VERIFICATION REPORT “SKHIDENERGO” LTD.

VERIFICATION OF THE **RECONSTRUCTION OF UNITS 1, 2, 3 AND 4 AT ZUYEVSKA THERMAL POWER PLANT.**

INITIAL AND 1ST PERIODIC (2009)

REPORT No. UKRAINE-VER/0148/2010

Figure 1: Data collection and processing for monitoring at Zuyevska TPP

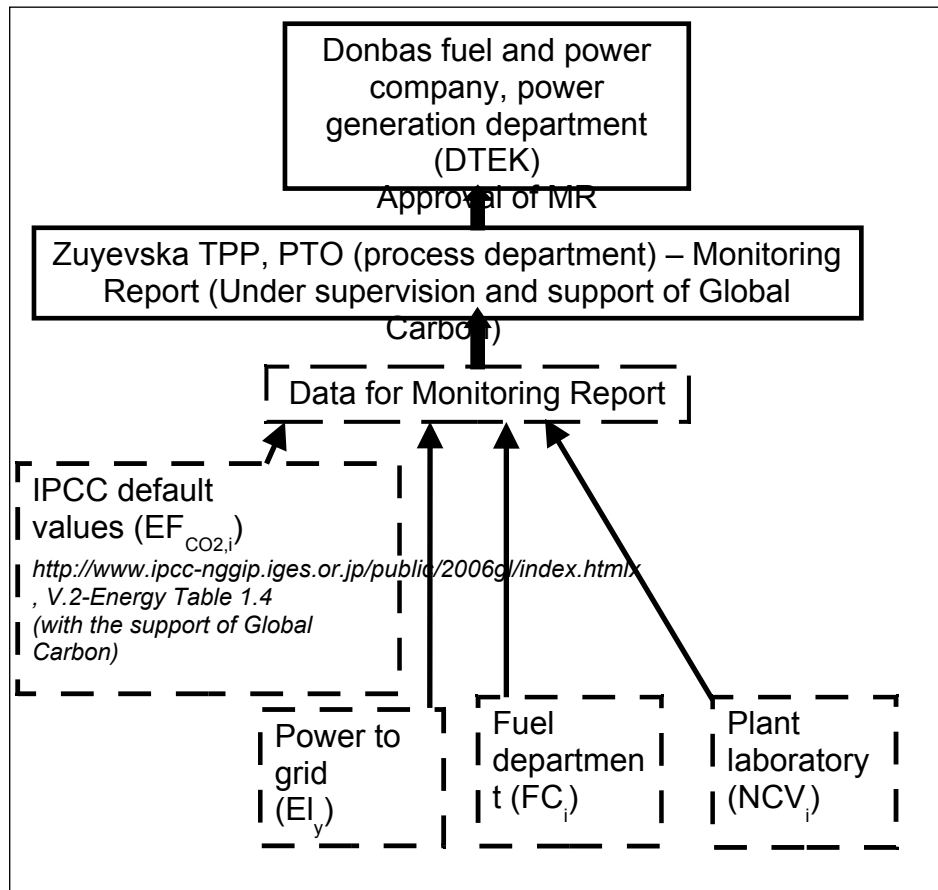
DVM Paragraph	Check Item	Initial finding	Action requested to project participants	Review of project Participants' action	Conclusion
		<p>archived necessary data.</p> <p>CL4: Please clarify in MR (Figure 2: Data collection and processing for monitoring at Zuyevska TPP) what is mean MP.</p> <p>CAR6: Global Carbon but not DTEK or station staff collected IPCC data. Please explain and correct this.</p>	<p>CL4: Misprint MP has been corrected to Monitoring Report in MR ver2.0. More detailed chart is provided.</p> <p>CAR 6: Corrected in Figure 2 in MR ver2.0. Role of Global Carbon is described.</p>	<p>The issue is closed.</p> <p>The issue is closed.</p>	
95 (a)	For calculating the emission reductions or enhancements of net removals, were key factors, e.g. those listed in 23 (b) (i)-(vii) above, influencing the baseline emissions or net removals and the activity level of the project and the emissions or removals as well as risks associated with the project taken into account, as appropriate?	CL5: Please mentioned and described 3 TECH form in MR.	CL5: Purpose and brief content of 3-TEH reporting form is provided in MR ver2.0 Section B.	The issue is closed.	OK
